# UNITED STATES PATENT AND TRADEMARK OFFICE

APPLICATION NO.	FILING DATE	FIRST NAMED INVENTOR	ATTORNEY DOCKET NO.	CONFIRMATION NO.
10/690,887	10/22/2003	John P. Finley	8471-0001CPA	6832

# Office Action Summary

# ATTACHMENT A

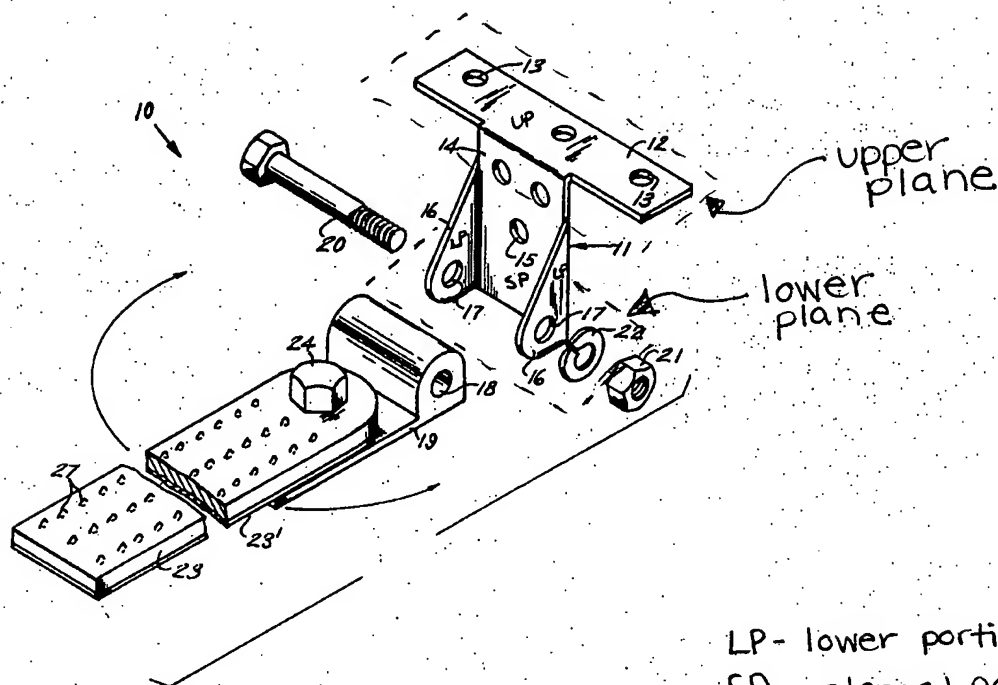
Veith discloses the claimed invention including a cleaning assembly (23) having a cleaning unit thereon (27), a mounting arm having a lower horizontal portion defining a lower plane (16; see Attachment A for visual explanation) coupled to and extending from the cleaning assembly (see Figures 1-2), a stepped portion (14), and an upper horizontal portion defining an upper plane (12) capable of being selectively coupled to a hitch receiver of a vehicle, the lower and upper planes being substantially parallel (see Figures 1-2, see Attachment A for visual explanation), the mounting arm further comprising a hinge (hinge is formed by members 17, 18, 20) including upwardly

Regarding Veith, US 3,740,072, the "Applicant asserts that the lower portion 16 does not present a horizontal plane parallel to an upper plane defined by the upper portion 12..." However, the Examiner points out above and in Attachment A that "16" *does* in fact include a lower horizontal portion (as it extends in a horizontal direction from 14) *defining* a lower plane (there are possibly *many* lower planes of which 16 defines, as shown in Attachment A, one lower plane may also be horizontal along the lower bottommost edges of 16) so that the lower and upper planes are substantially parallel (see again Attachment A). The lower portion 16 has three dimensional characteristics, as shown in the Figures, and thus has a horizontal portion that defines a lower plane parallel to the upper plane. Additionally, there is a hinge disposed *on* the lower plane of

the lower portion of the mounting arm, in that components that make up the hinge, 17, 20, are geometrically "on" the lower plane.

LP - lower portion (16)  
SP - stepped portion (14)  
UP - upper portion (12)
